SD-EA.378

MODIFICATION OF TYPE APPROVAL

CANADIAN GENERAL ELECTRIC TYPES "I-50A" AND "I-55A" WATTHOUR METERS

CANADIAN GENERAL ELECTRIC TYPES "I-50A" AND "I-55A" METER BASE

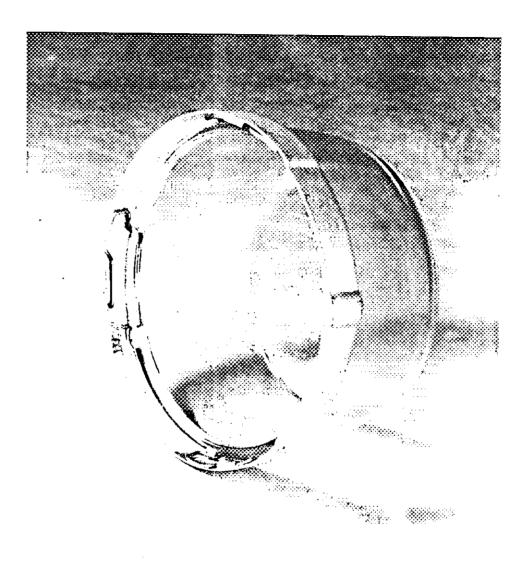
Modifications: The modifications are as follows:-

- 1) The provision of removable seal pans;
 - 2) New means for locking the terminal block by means of a pen attached to the sealing clip, which eliminates the need for the screw through the seal pan;
 - 3) Glass covers with removable cover rings which are held in place by spring sealing clips.
